Reference: WE905-08F02(rev0)- SR Memo

**RE: GRAN CENTRAL, 134-142 PARRAMATTA ROAD, 26-38 GOOD STREET &
56-61 COWPER STREET, GRANVILLE
SOLAR LIGHT REFELCTIVITY RESPONSE MEMO**

This memo provides comments on the responses provided by Flux(report ref: DA_655_2019 - 134-142 Parramatta Road Granville, dated 12th May, 2020); on behalf of the City of Parramatta Council, in relation to the Solar Reflectivity Report prepared by Windtech (report ref: WE905-02F01(rev0)- SR Report, dated 18th October, 2019) and subsequent Response Statement (Windtech - SR E-mail Response, issued 16th March 2020), for the subject development known as Gran Central, 134-142 Parramatta Road, 26-38 Good Street and 59-61 Cowper Street, Granville. Since the time of the study, design changes were made to the subject building to incorporate additional effective glare mitigation elements into the subject development; as indicated in the latest architectural drawings prepared by the project architects PBD Architects received August 2020.

Figure A.2: Glare Overlay of the Viewpoint at Point 02

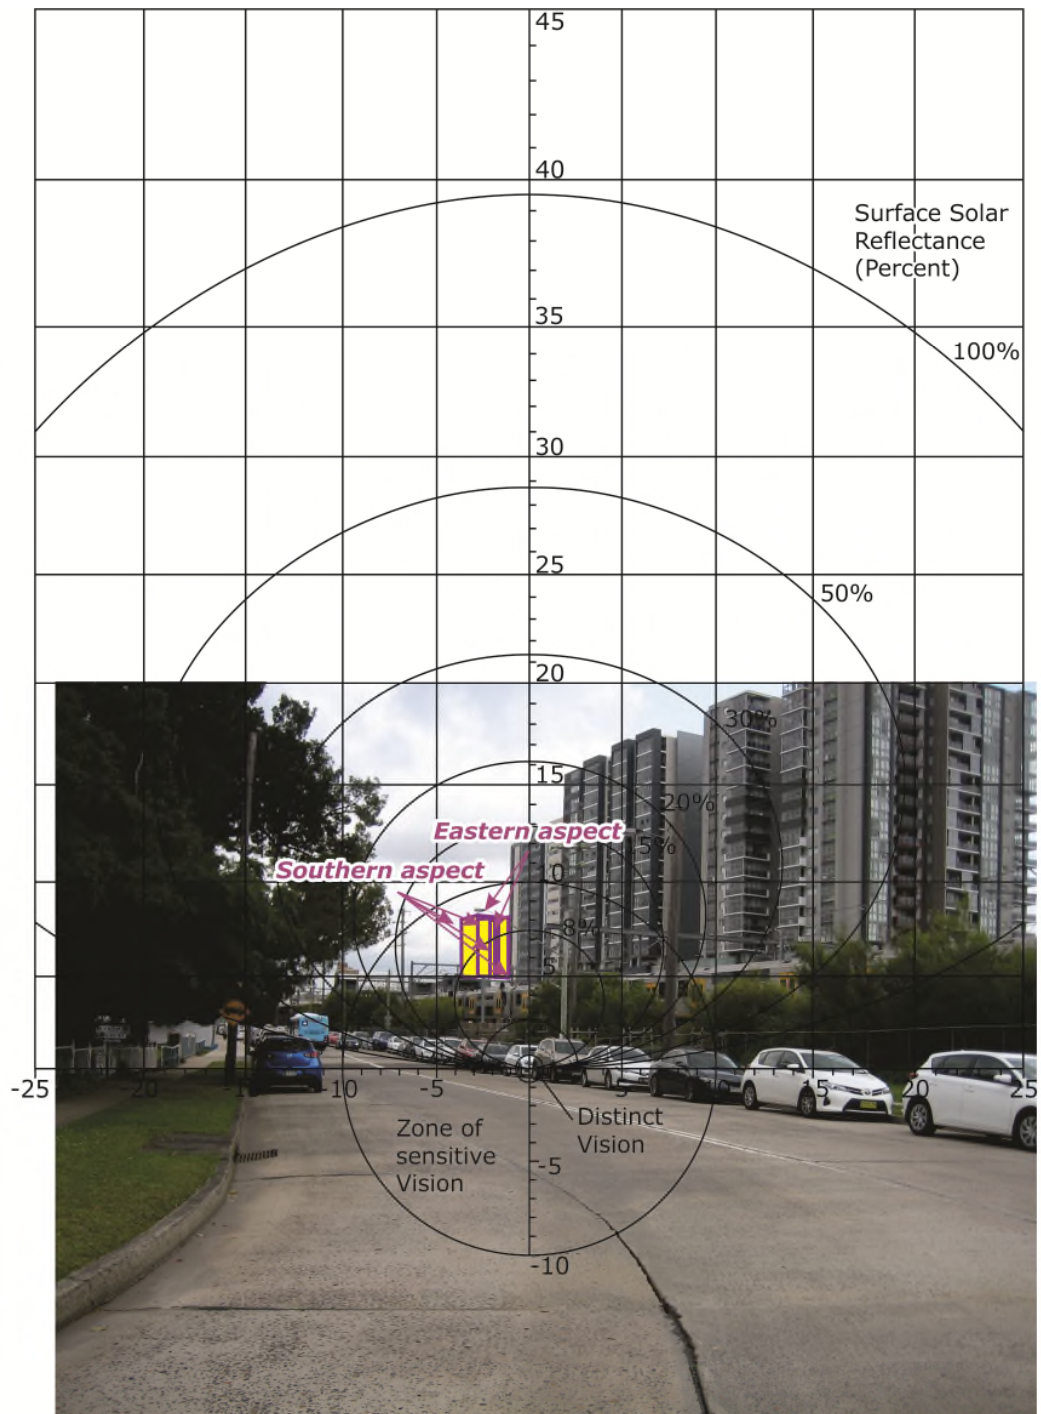
The reanalysis of the viewpoint at Point 02 indicates that portions of the eastern (Tower B) and southern (Tower A and B) and will be visible at this location. The study point location is within the check zone of the eastern and southern facades of the subject development. The angle of incidences to the eastern façade is less than 40° whereas the angle of incidences from to the southern façade is greater than 40°. The glare risk assessment of the visible facades is summarised as follows:

- Eastern Facade - The angle of incidences from the eastern facade is less than 40°. An inspection of the latest architectural drawings indicates the visible eastern façade of Tower B will be comprised of rendered cladding and narrow width windows. It should be noted the tower form of Tower B is connected to Tower A at all levels and as such the incident sun rays would be obstructed by Tower A. Hence there is be no adverse solar glare risk to motorists from the visible eastern façade.

- Southern Facade - The angle of incidences from the southern facade is greater than 40°. An inspection of the latest architectural drawings indicate the visible southern façades of Towers A and B is comprised of a combination of rendered cladding, narrow glazed windows on the main building façade and apartments with south-facing balconies. Furthermore, the architectural drawings indicate the latest design has incorporated glare mitigations along the southern façade. These include extending the full-height blade walls along the balcony perimeter edge of the south-facing balconies and inclusion of vertical fins at the eastern and western ends of the narrow-glazed windows. Hence there is be no adverse solar glare risk to motorists from the visible eastern façade.

Figure A.3: Glare Overlay of the Viewpoint at Point 03

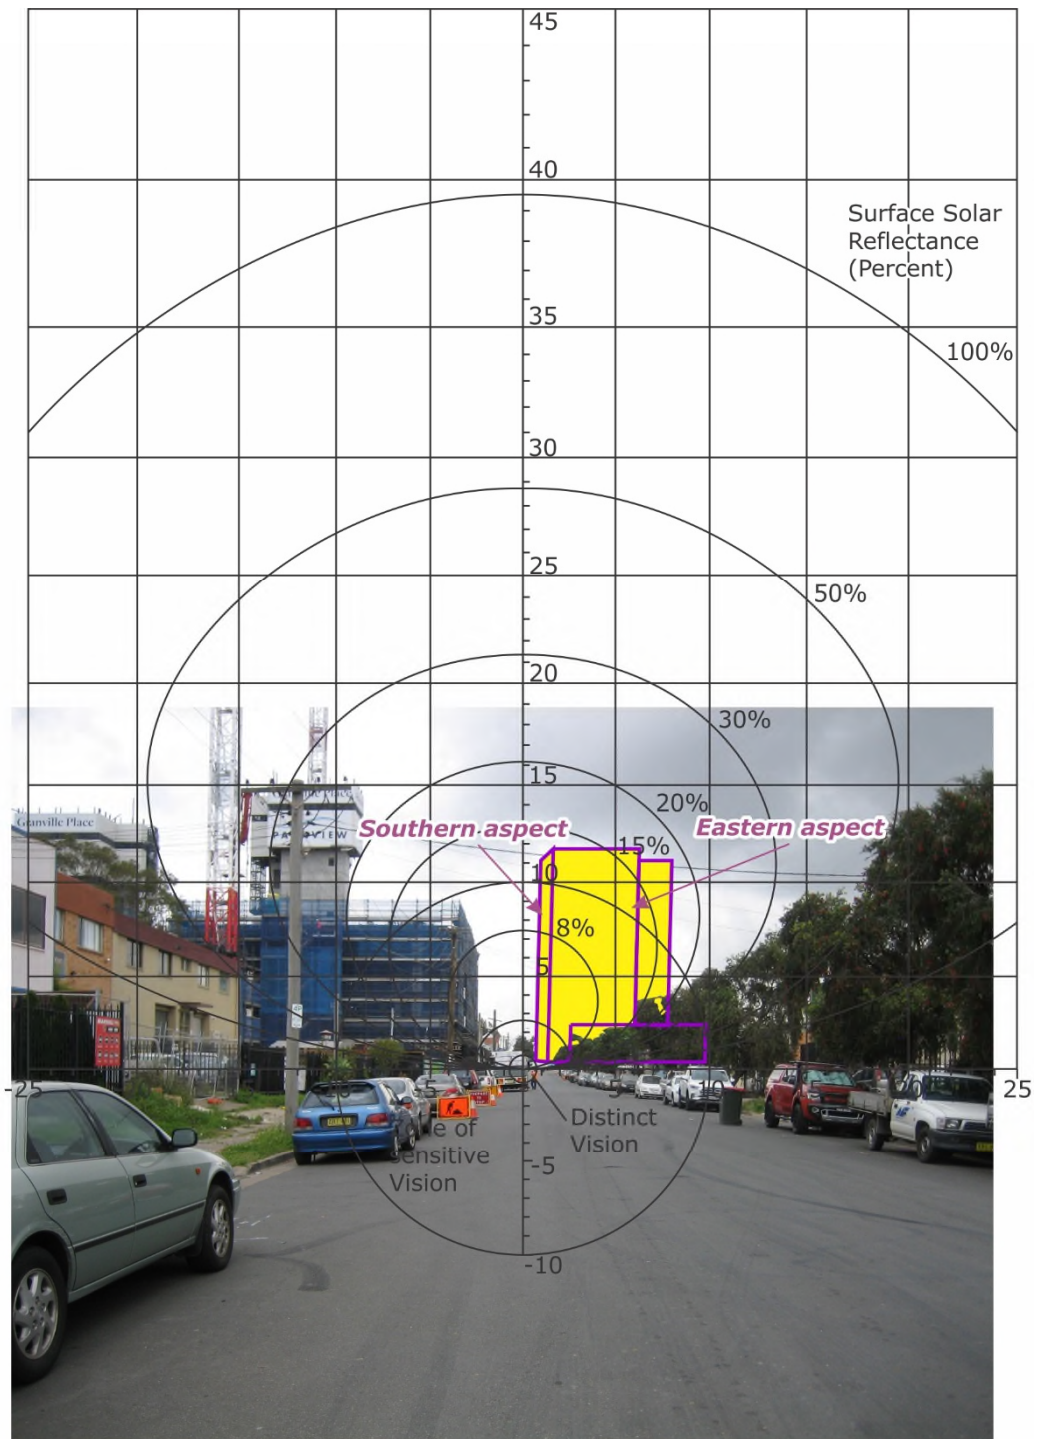
The reanalysis of the viewpoint at Point 03 indicates that portions of the eastern facade (Tower A) and southern (Podium, Tower A and B) will be visible at this location. The study point location is within the check zone of the eastern and southern facades of the subject development. The angle of incidences to the eastern facade is less than 40° whereas the angle of incidences from to the southern facade is greater than 40°. The glare risk assessment of the visible facades is summarised as follows:

- Eastern Facade - The angle of incidences from the eastern facade is less than 40°. An inspection of the latest architectural drawings indicates the visible eastern facade of Tower B will be comprised of a combination of rendered cladding, narrow-width glazed windows on the main building facade and apartments with east-facing balconies. The glare risk from the Podium Levels are expected to be minimal due to the shielding provided by the surrounding buildings and the proposed landscaping; in the form of trees and planters as indicated in the architectural drawings. Although the remaining upper podium levels do not benefit from the obstruction afforded by the adjacent buildings and proposed landscaping, the narrow-width windows and balcony-facing glazed systems benefits from the recession into the podium building footprint. The tower facade does not benefit from the obstruction afforded by the adjacent buildings and proposed landscaping. The veiling luminance can vary along the tower facade from 1300cd/m² from southern edge to under 500cd/m² at the northern edge for a reflectance value of 11%. The latest design of the development has incorporated a number of glare mitigation strategies to minimise the glare risk onto the motorists, summarised as follows:

- o The use of glazing along the eastern main building facade and glazed balustrades with low specular reflectance values of 11% and 8% respectively.
- Southern Facade - The angle of incidences from the southern facade is greater than 40°. An inspection of the latest architectural drawings indicate the visible southern facades of Towers A and B is comprised of a combination of rendered cladding, narrow glazed windows on the main building facade and apartments with south-facing balconies. For solar glare to be reflected off the southern facade of the Tower A and Tower B, this would occur at certain times of the year in the late afternoon. However, during late afternoon period when the reflected solar glare can be observed, the direct sun will also be visible to motorists at this location. Hence the intensity of the

- o Reducing the glazed surface area along the eastern building facade wall abutting the balcony, through the addition of nib solid walls; strategically placed at the southern section of facade.

- o The inclusion of full-height 'MP' screens along the eastern perimeter edge of the balconies/ narrow-width windows to obstruct the incident sun and mitigate the reflected glare. The full-height 'MP' screens further assists by reducing the angular widths of the visible glazed systems under 0.5°. As the sun subtends an angular width of 0.5°, the full-height 'MP' screens minimise the possibility of the full intensity of the solar glare from being observed off these visible glazed systems.

Figure A.4: Glare Overlay of the Viewpoint at Point 04

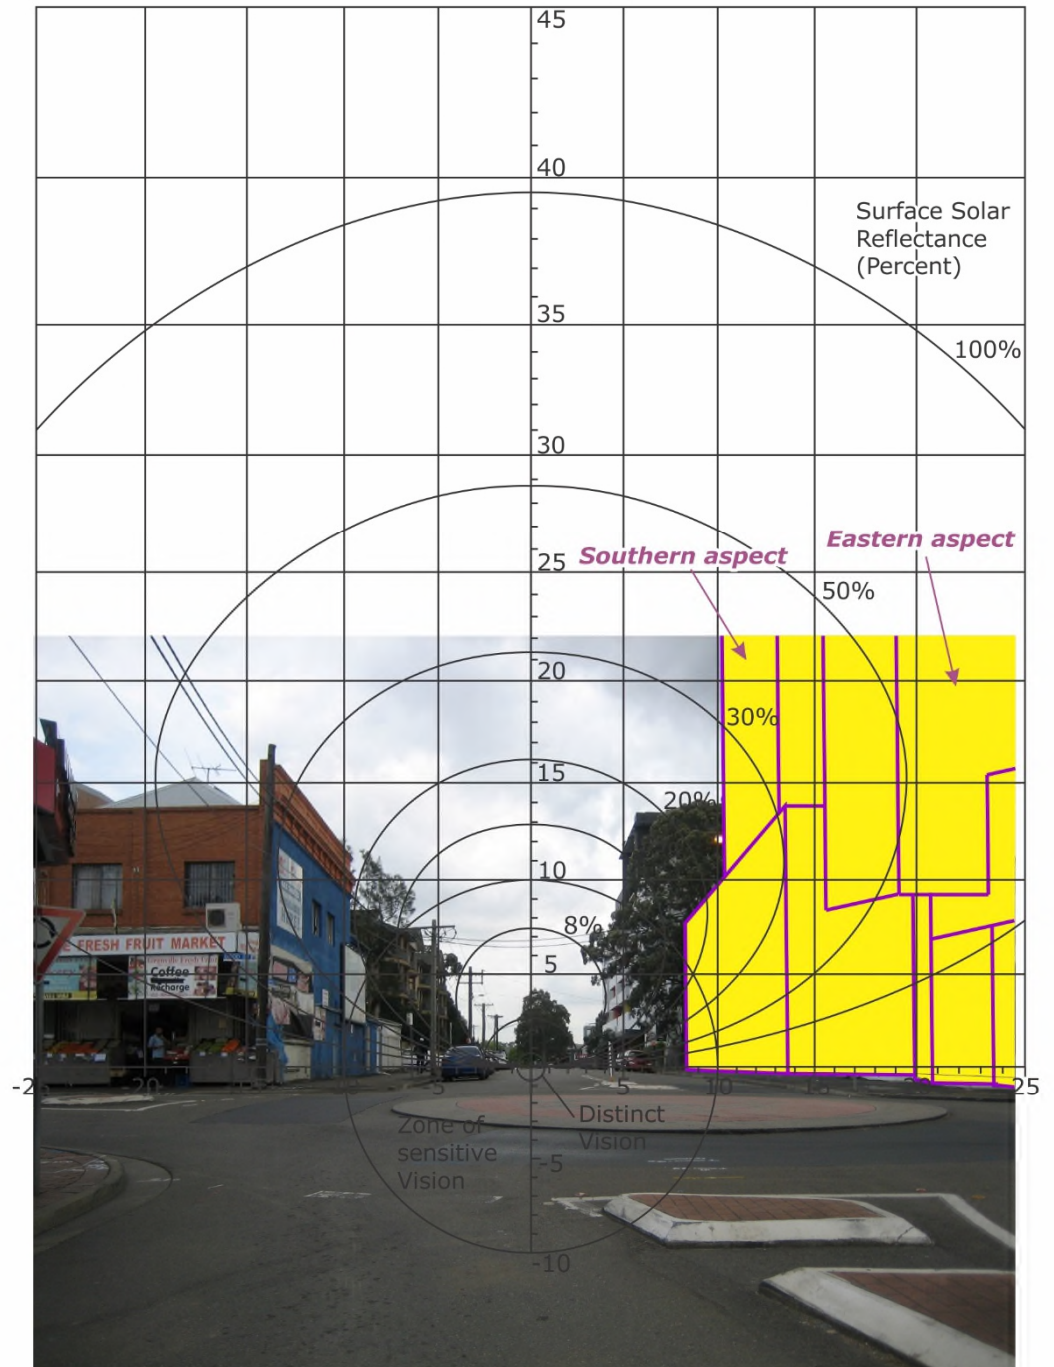
Furthermore, although the intensity of the direct sun would be more severe than the reflected glare off the aspect, our analysis does also provide a recommendation for the normal specular reflectance of the aspect for when the direct sun may be obscured but reflected glare is still possible (e.g. for Figure A.4 we recommend the critical southern aspect to have a maximum normal specular reflectance of 20%).

- For motorists heading west along Cowper Street at the roundabout, please refer to the analysis for Study Point location 04 and Figure A.4. Please note the additional commentary provided above regarding the queries about the direct sun/reflected glare and our response regarding recommended reflectance values.*

Figure A.9: Glare Overlay of the Viewpoint at Point 09

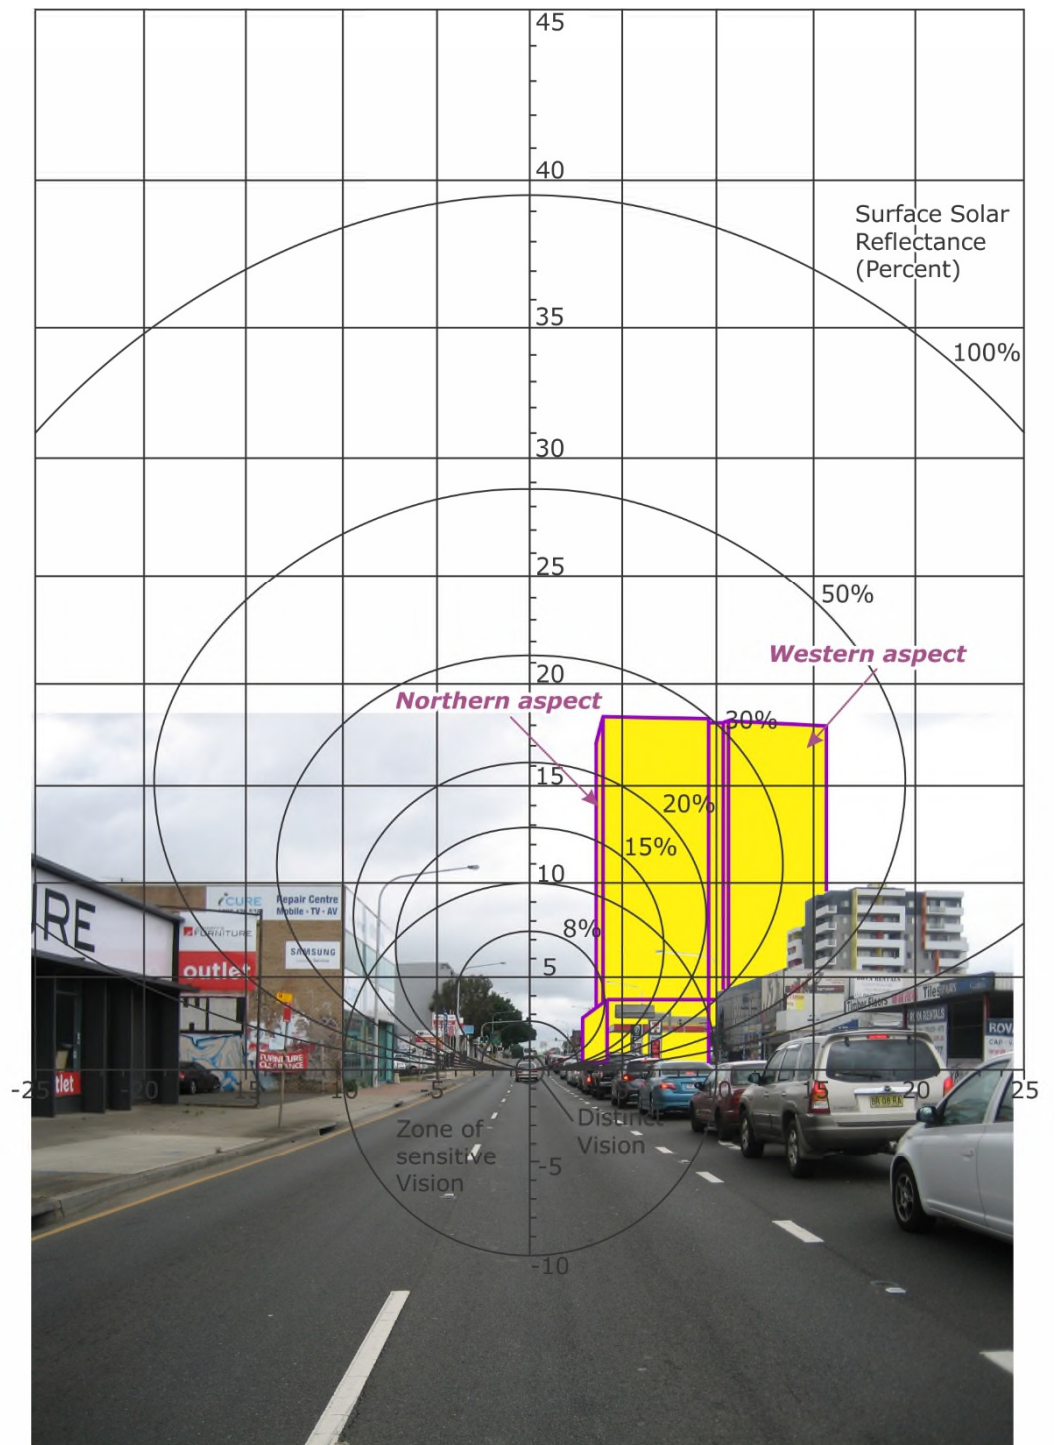
The reanalysis of the viewpoint at Point 09 indicates that portions of the western (Podium and Tower B) and northern facade (Podium and Tower B) will be visible at this location. The study point location is within the check zone of the western and northern facades of the subject development. The angle of incidences to the western façade is less than 40° whereas the angle of incidences from to the northern façade is greater than 40°. The glare risk assessment of the visible facades is summarised as follows:

- Western Facade - The angle of incidences from the eastern facade is less than 40°. An inspection of the latest architectural drawings indicates the visible podium façade is comprised of entirely of cladding with no glazed systems, hence there will be no glare risk to the motorists from the podium façade. The visible eastern façade of Tower B is be comprised of a combination of rendered cladding, narrow-width glazed windows on the main building façade and apartments with west-facing balconies. The veiling luminance can vary along the tower façade from 700cd/m² from northern edge to under 500cd/m² at the southern edge for a reflectance value of 11%. A further investigation indicates the tower façade sections that is above the 500cd/m² is comprised of rendered cladding. At the glazed systems locations, the veiling luminance reduces to 460cd/m². Hence the glazing along the western main building façade is recommended to have a specular reflectance value of 11%.

- Northern Facade - The angle of incidences from the northern facade is greater than 40°. An inspection of the latest architectural drawings indicate the northern façades of the Podium and Tower B is comprised of a combination of rendered cladding, narrow glazed windows on the main building façade and apartments with north-facing balconies. For solar glare to be reflected off the northern facade of the of the Podium and Tower B, this would occur at certain times of the year in the early morning. However, during early morning period when the reflected solar glare can be observed, the direct sun will also be visible to motorists at this location. Hence the intensity of the direct sun would be a more severe hazard and glare risk to motorists than the reflected glare off the southern façade. Furthermore, the proposed landscaping along the Parramatta Road frontage of the site is effective in obstructing the view of the northern podium façade to the motorists.
